INTERNAL CORRESPONDENCE

SUBJECT: ECO Matrix and rework for IPB, IOC, DRR Boards REV 3

This document contains the rework required to up-grade the IOC, IPB, DRR Channel and interface boards to the latest correct dash and REV level.

FIGURE 1

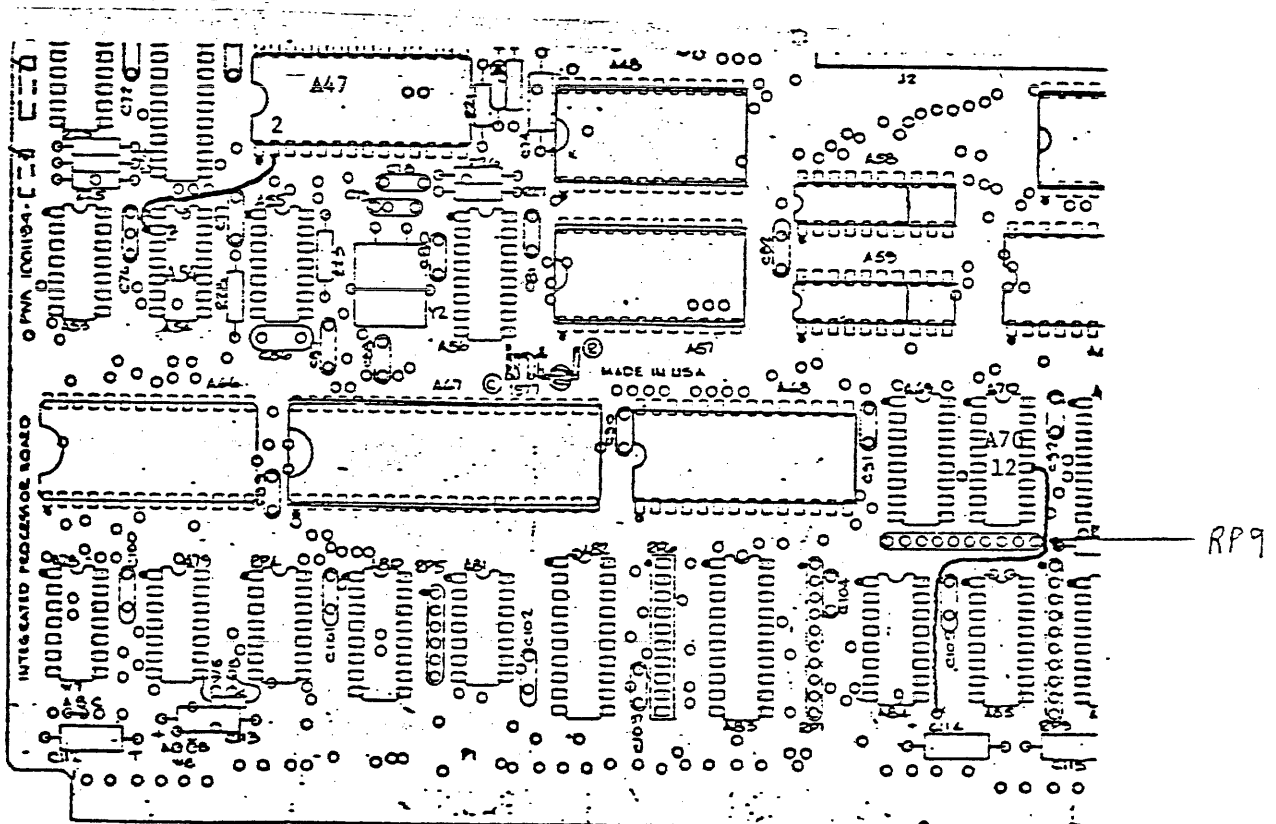
1. Replace IC 101502-001 in location A70 with IC 102899-001.
2. Remove A54 pin 2 from pad on the board and bend lead straight out from body of IC

3. On solder side, cut the trace running from RP9-3 to the feed thru located near A84-9. (See figure 1).

4. On component side, install a jumper from the feed thru located below and to the right of A84-9 to A70-12.
5. On component side, install a jumper from the lead of A54-2 to A47-2.

ECO 2-4556A

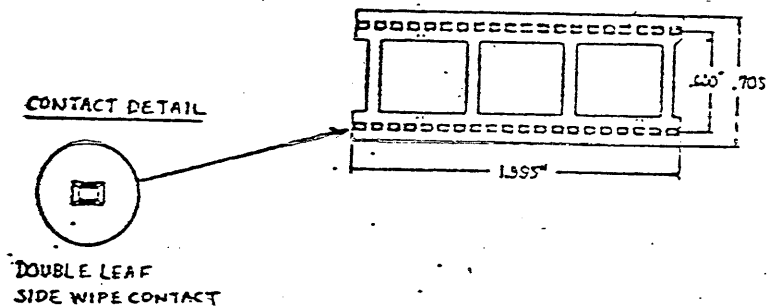
1. Remove the 8080 at location A67.
2. Inspect the 40 pin socket for the type shown below:

The 40-pin sockets to be replaced are Intel P/N 101555-040 (typical example shown below):

3. If PWA does have the above sockets, remove all 40-pin sockets shown above.
If PWA does not have this type of socket, replace IC's in sockets (socket is then of the right type).
4. Replace 40-pin socket with Scanbe or Augat type socket (P/N 101581-040 or 102989-001).
5. Replace IC into socket.

ECO 1945

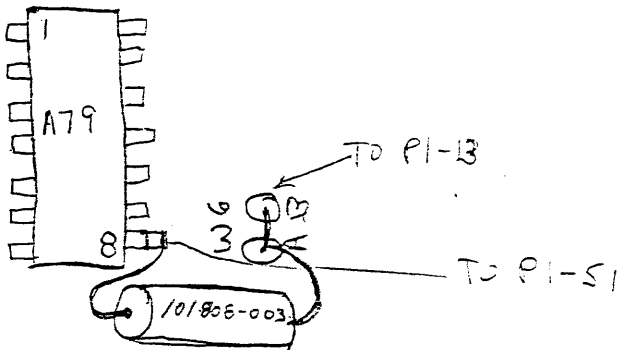
Add .22 uh choke to clock service line

1. Clip pin A79-8 flush with PCB and bend up pin.
2. Solder choke .22 uh (101808-003) from A79-8 to adjacent jumper wire as shown in below.

FIGURE 1

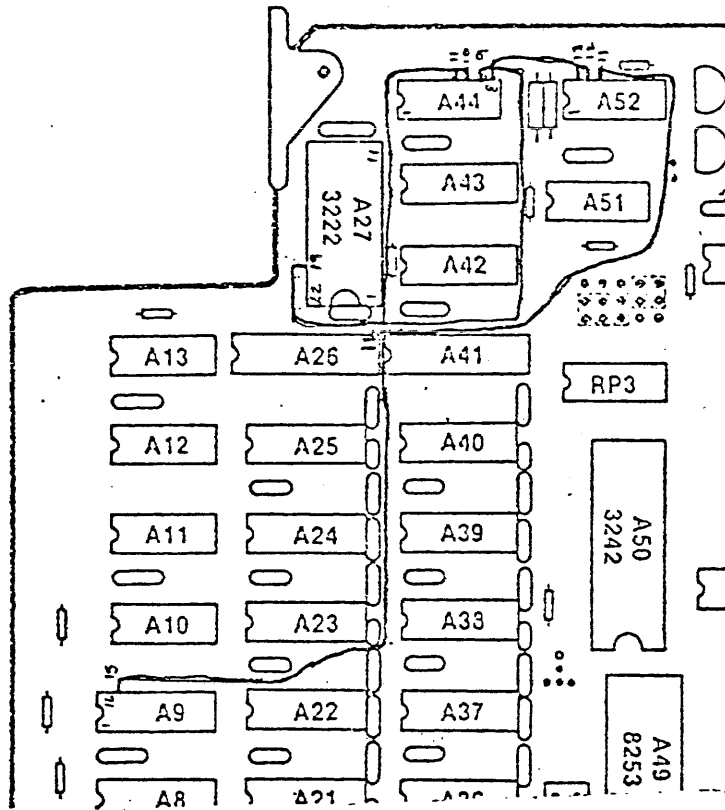
1. Replace all 74S74 (100913-001) with 74LS74 (100914-001)
2. Cut trace from A9-15 to A26-11
3. Add jumpers as follows, (see figure 1):

<u>FROM</u>	<u>TO</u>
A27-19	A44-9
A9-15	A44-10 & 11
A44-8	A52-12 & 13
A52-11	A26-11

ROUTING FOR ECO 2210

20 BIT ADDRESS PIGGY-BACK BOARD

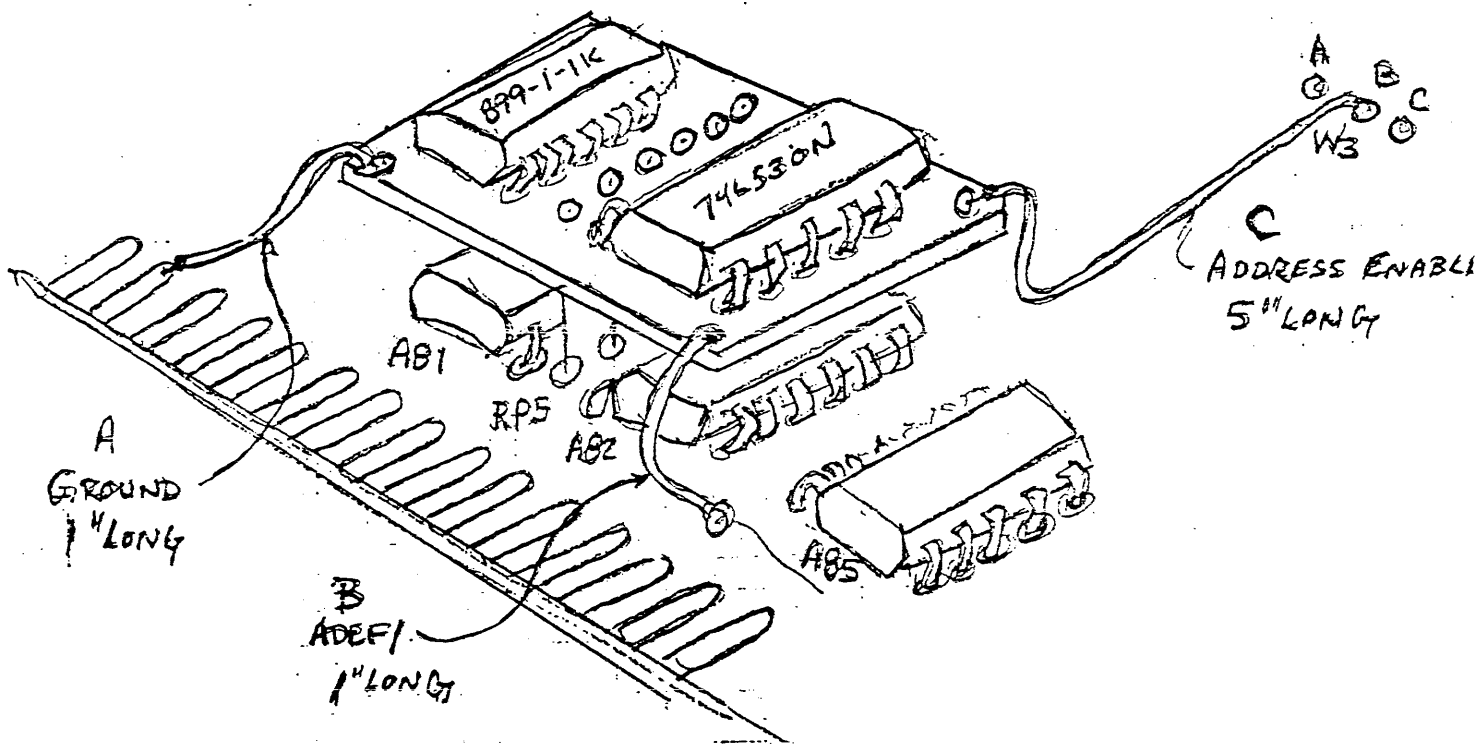
P/N 1002234-01

1. Remove RP5, A SIP resistor package
2. Fit prongs of piggy-back board into holes of RP5 and solder
3. Solder Jumper A to ground
4. Solder Jumper B to ADRF/ at feed through
5. Solder Jumper C to jumper feed through W3-B

ECO 2-4565

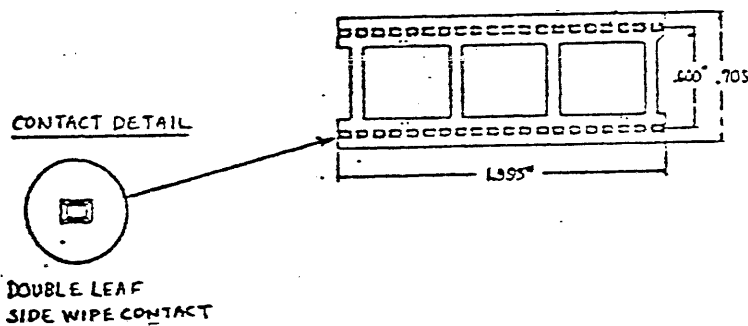
1. Remove 40 pin IC's at locations A1, A20, A58, A69 and A72.
2. Inspect 40 pin sockets for the type shown below:
The 40-pin sockets to be replaced are Intel P/N 68-234 (typical example shown below)

3. If PWA does not have this type of socket, replace IC's in sockets (sockets are then of the right type).
4. If PWA does have the above sockets, remove all 40-pin sockets shown above.
5. Replace 40-pin sockets with Scanbe or Augat type (P/N 102989-00 or 101581-040)
6. Replace IC's in sockets

ECO 2-3629

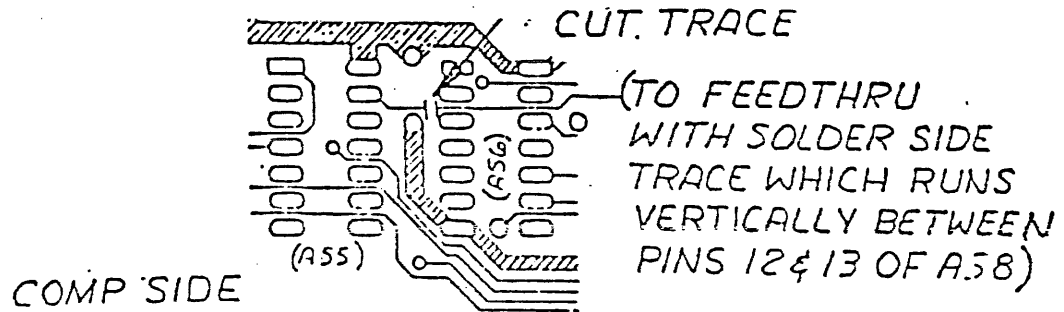
1. Cut trace running to A55-13, from feed thru

2. Add jumper wire from feed thru just cut to A56-2
3. Add jumper from A72-7 to A72-20 (GND)

ECO 2-5304

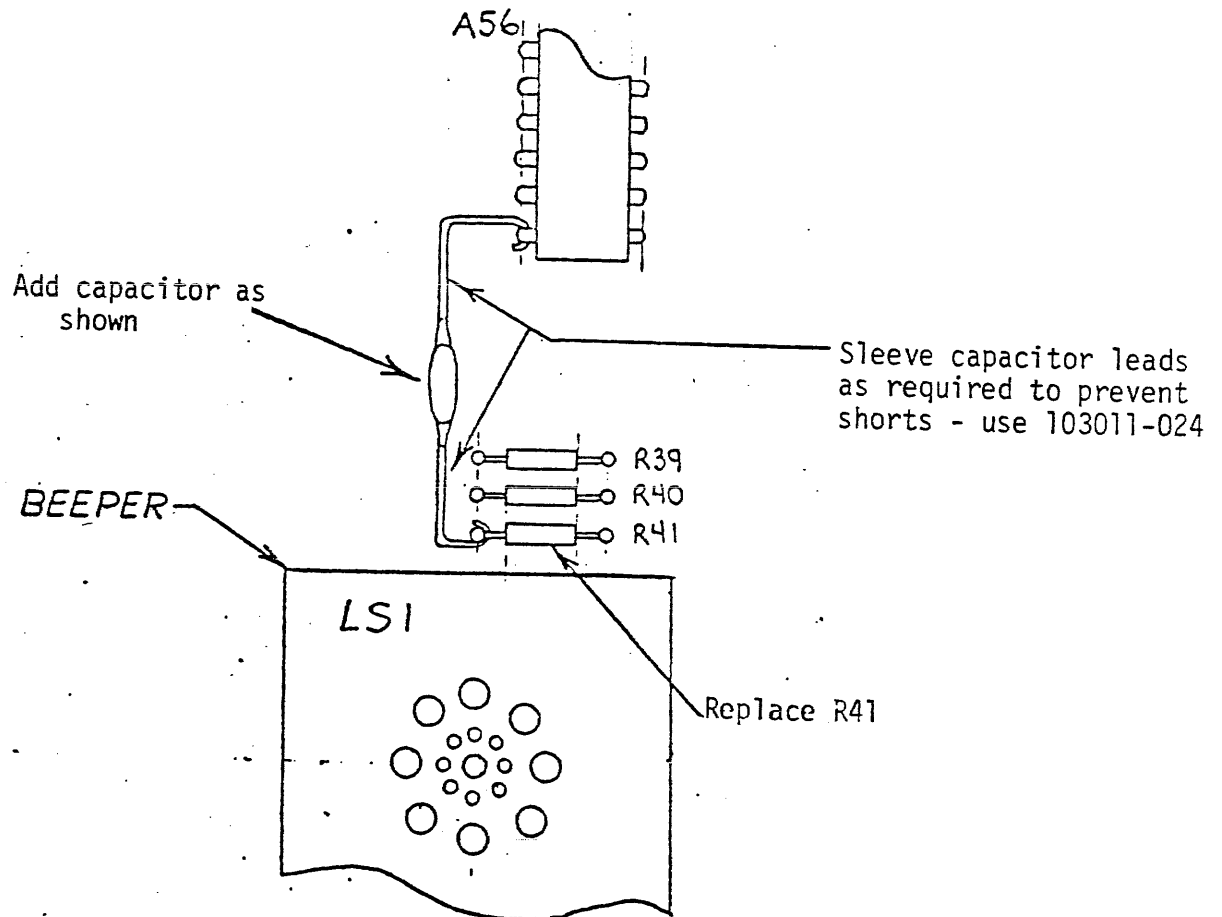
1. Remove resistor R41 (1K 5% $\frac{1}{4}W$) and replace with:
(1ea) 101656-06Z resistor 750 $\frac{1}{4}W$ 5%.
2. Add (1ea) capacitor P/N 101754-049, CER. 0.1 UF 50V. Between A56-7 (gnd)
and R41, per sketch below. (Sleeve leads as shown)

ECO 2-2699A

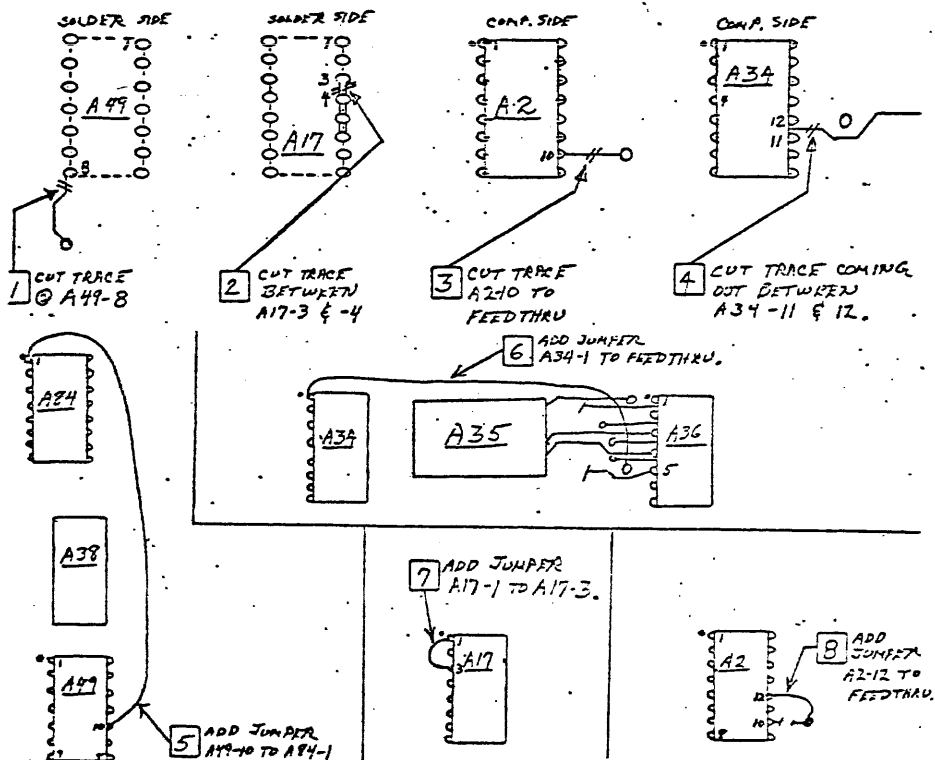
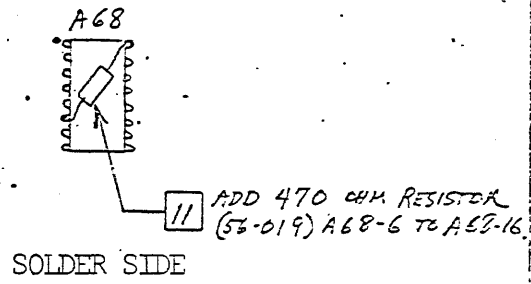
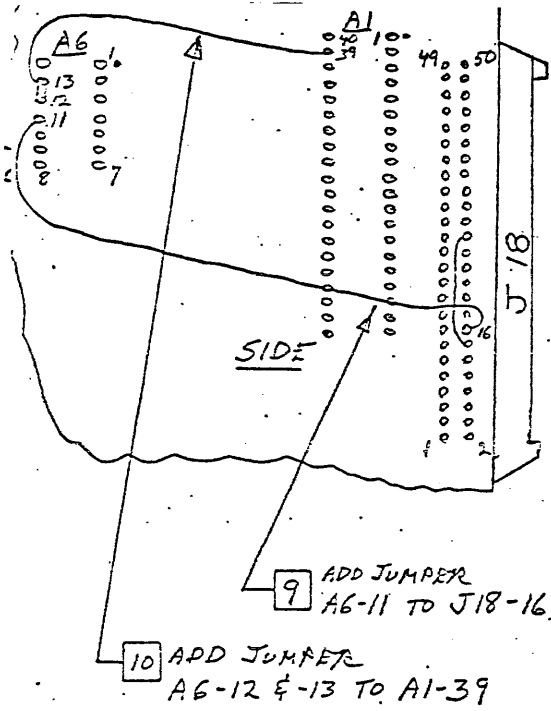
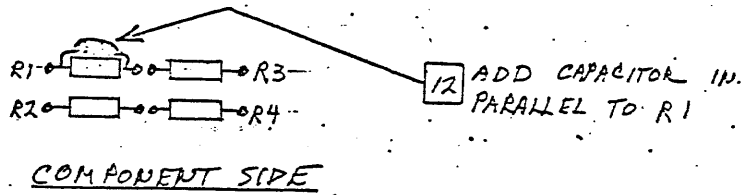
1. Cut trace (solder side) at A49-8.
2. Cut trace (solder side) between A17-3 and A17-4.
3. Cut trace (component side) A2-10 to feed through.
4. Cut trace emerging from under A34 (comp. side) between pins.
5. Add jumper from A49-10 to A84-1 (component side)
6. Add jumper from A34-1 to feed through adjacent to A36-5 (component side)
7. Add jumper from A17-1 to A17-3 (component side)
8. Add jumper from feed through adjacent to A2-10 to A2-12 (component side)
9. Add jumper from A6-11 to J18-16 (solder side)
10. Add jumper from A6-12 & 13 to A1-39 (solder side)
11. Add (1 ea.) 470 Ω resistor (P/N 101656-022) from A68-6 to A68-16 (component side)
12. Add capacitor C-90 in parallel to resistor R1. P/N 101766-037 CAP. CER, .01 μ F +80, -20% 25V.

ECO 2-3774

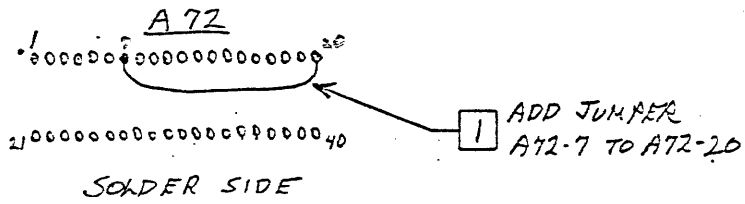
1. Add jumper from A72-7 to A72-20 (gnd) or equivalent

ECO 2-4578

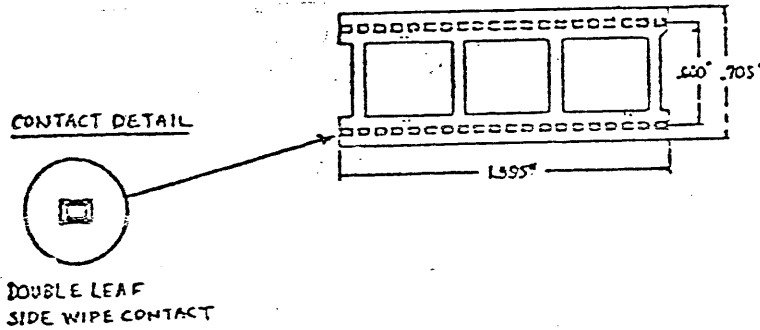
1. Remove 40 pin IC's at locations A1 (8271), A20 (8275), A58 (8257), A69 (8080A-2), and A72 (8741-4).
2. Inspect 40 pin sockets for the type shown below:

3. If PWA does have the above sockets, remove all 40-pin sockets shown above.
4. Replace 40 pin sockets with Intel P/N 102989-001.
5. Replace IC's in sockets.

FIGURE 1

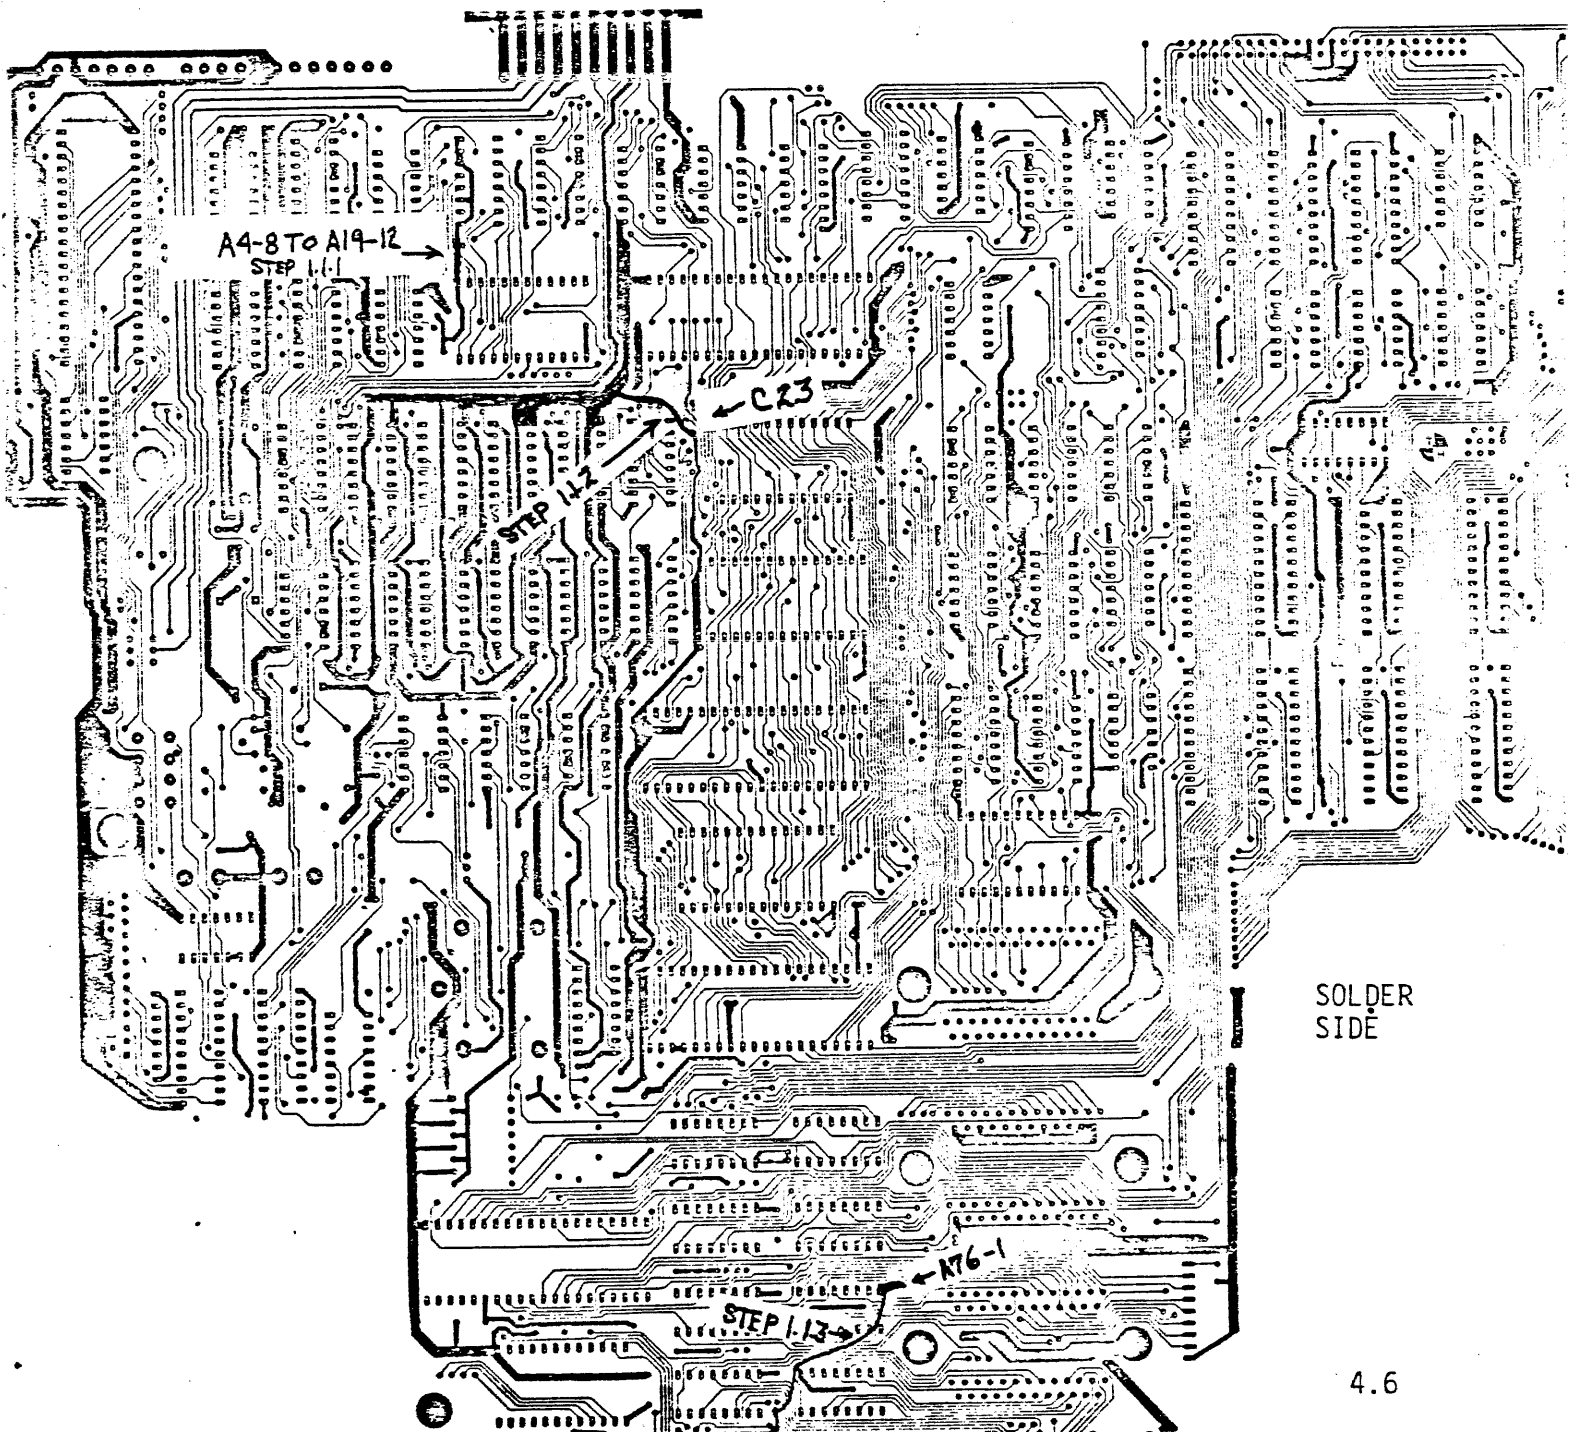
1. Add 12 jumpers using 20AWG green stranded wire per the following:

1.1.1 From A4-8 to A19-12 (gnd)

1.1.3 From feedthru adjacent to C87 and A78-16 to A76-1.
